REMARKS

Summary of the Office Action

Summary of the Response to the Office Action

FIG. 1

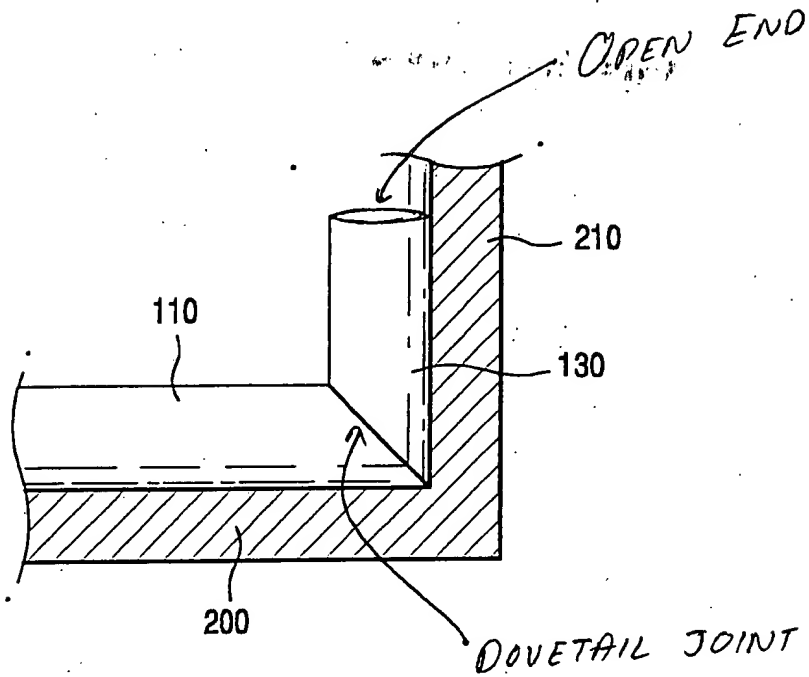
In the Office Action, the drawings stand objected to.

In the Office Action, the drawings stand objected to.

As required in the Office Action, Fig. 1 has been amended to disclose the open ends of the vertical pipes and a conventional dovetail joint which connects the horizontal and vertical pipes.
